**SSI Rapport**

**2002:17** RICHARD KLOS AND ROGER WILMOT

*Review of Project SAFE:  
Comments on biosphere  
conceptual model description and risk  
assessment methodology*

**Figure 4**  
*Total dose from release of radionuclides from SFR 1 to the reasonable biosphere [Lindgren et al., 2001]. Discontinuities in dose arise from the step change to alternate biosphere system models.*

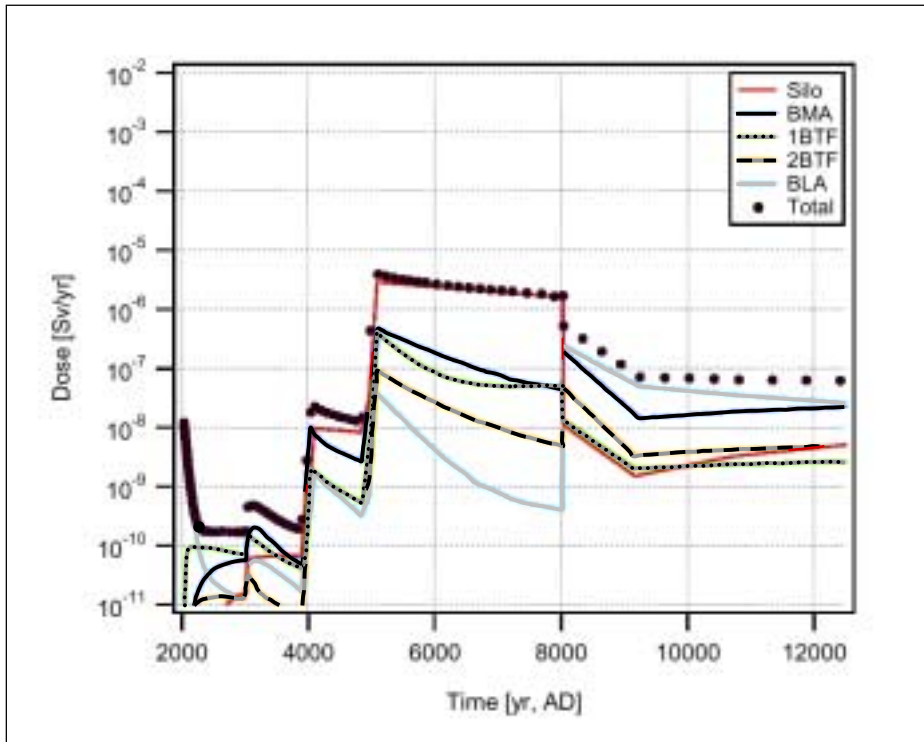
The individual system states are identified in SAFE to the extent that separate descriptions are provided. At the numerical modelling stage the question of system *memory* is included but the discussion of transition from one stage to another is not dealt with in detail.

The link between the conceptualisation of the system and the numerical models would have been much clearer had there been a mapping of the numerical assessment model domains on to the physical biosphere system. At the descriptive level there is a detailed conceptual account of how the system responds to land rise but the NAMs used are not linked directly to geographical locations. A series of maps, showing release point and assessment model domain as a function of time, indicating the location of the various biosphere sub-models, would have helped.

As a result, although residual contamination in the biosphere is allowed in the NAMs, the description of how the modelled system represented at later times has evolved from that at earlier time is not clear. Transition states are not discussed other than to say that residual contamination is included in the initial conditions of later NAMs. The biosphere IM encompasses all of the FEPs but does not adequately express spatial and still temporal structures.

**Figure 5**  
 Structure of the coastal model used in the SAFE study. The 'X' denotes the compartment receiving radionuclides from the disposal system far-field. Transfers of radionuclides within the system are marked with arrows [Karlsson et al., 2001].

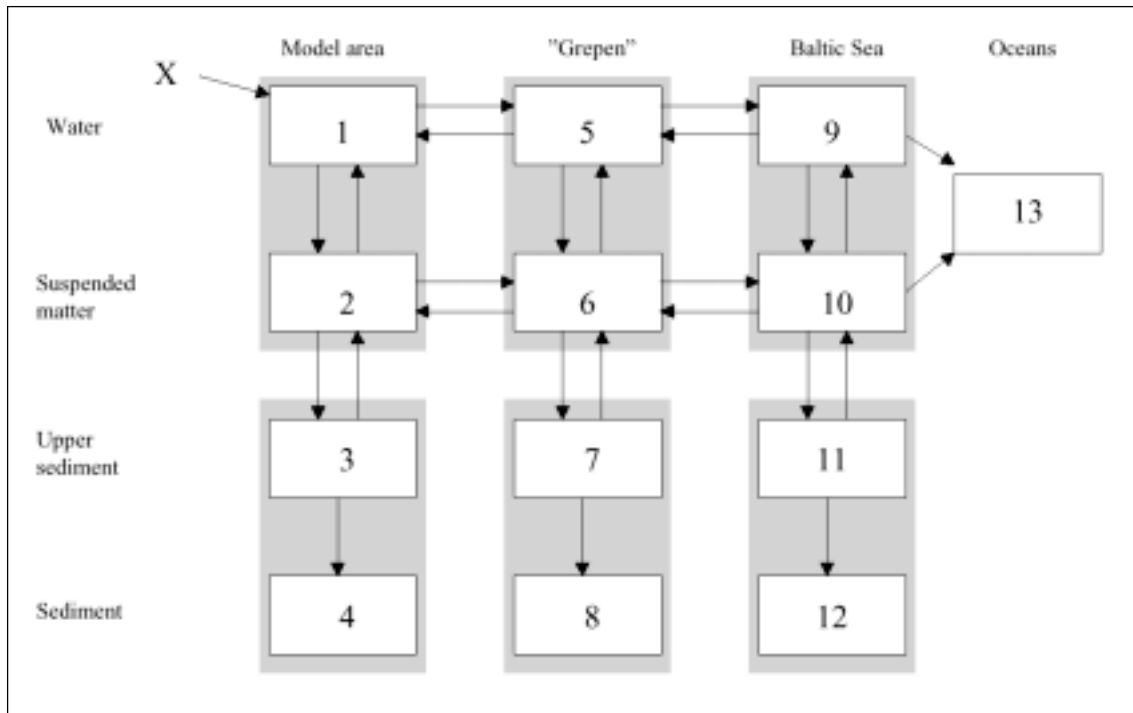
In the corresponding numerical assessment model [Karlsson *et al.*, 2001], the coastal model has the structure shown in Figure 5. Sedimentation rates are low in the region and the modelling assumption is that the thickness of the upper sediment is 0.02 m (ranging from 0.5 cm to 5 cm in sensitivity studies). The lower 'Sediment' has an undefined thickness because it is used as a sink compartment. Sediment accumulates at a rate of  $0.01 \text{ m y}^{-1}$ , effectively transporting material to the deeper sediment compartment by burial. Thus, because the radionuclides enter the water column from the geosphere, the NAM assumes that there is sedimentation throughout the model area, when in fact it is only in limited areas in the Öregrundsgrepen (Figure 6-1 of Kautsky [2001]). The reason for this assumption is that there is need to accumulate radionuclides in the modelled system in order to provide a conservative assessment of radiological impact.

Release of contaminated groundwaters is likely to be *through* the bay sediments. Without a discussion of what underlies the sand, gravel, stones and boulders of the rocky bottom, it is not possible to say if it is reasonable to assume that discharge is effectively to the water column as a consequence of low sorption on large-scale material at the sediment-water column interface. Neither is it possible to evaluate the potential for accumulation of radionuclides at the bottom of the bay. It is also important to recognise that retardation and retention of radionuclides on boulders might be different to that on sand. It seems inconsistent then to assume that the lower sediment can accumulate radionuclides through burial but contaminated groundwaters flowing through them are assumed not to interact.

There may be very good reasons for the system to be modelled in the way it is but documentation of the possibilities and alternatives is not given. The potential for accumulation in the system is therefore overlooked.

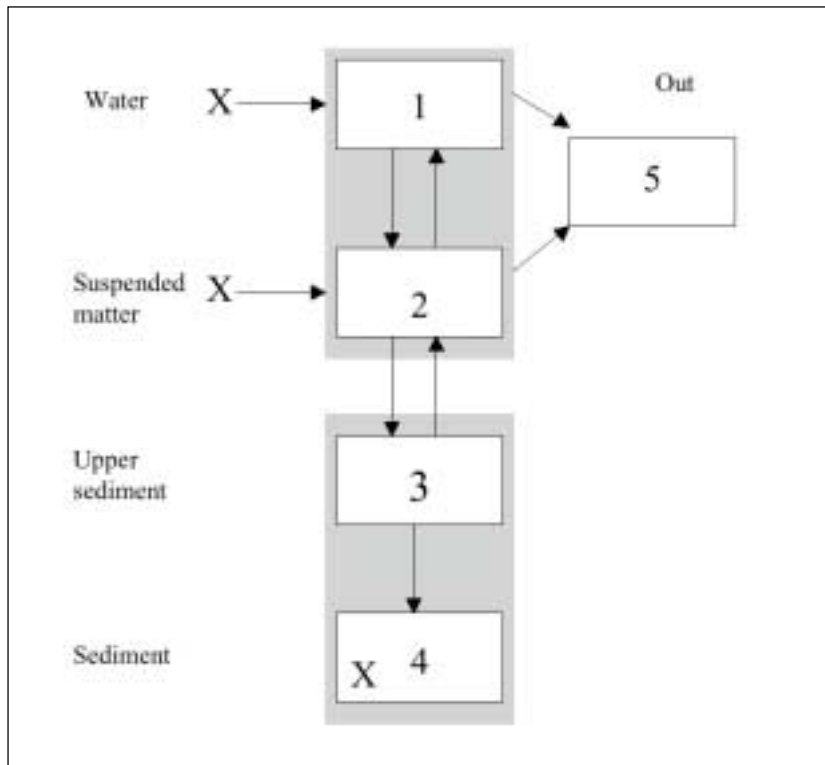
It is therefore clear that the flow of groundwater *through* the bed sediment layers of lakes is an important feature in lakes. The review in Kautsky [2001] goes on to discuss the dike theory, where the sediments are impermeable, as well as the sieve theory. The sieve theory has clear implications for the filtering and accumulation of waterborne contaminants<sup>5</sup>. No discussion of the potential implications is found in the description of the NAM. The input of radionuclides to the lake is via solution and suspended solid material from outside the system, see Figure 6.

The description of the leading diagonal elements of the biosphere interaction matrix is not sufficient to take this kind of material into account. The analysis would be clearer were SKB to provide a further level of interaction matrix, concerned with radionuclide transport.

The biosphere interaction matrix in SKB [2001b] shows that the geosphere interacts directly with quaternary deposits (solid and water), surface water and humans, and via heat transport. This level of discussion does not provide the justification for the treatment of the geosphere-biosphere interface in the biosphere models, as shown in Figures 5 and 6.
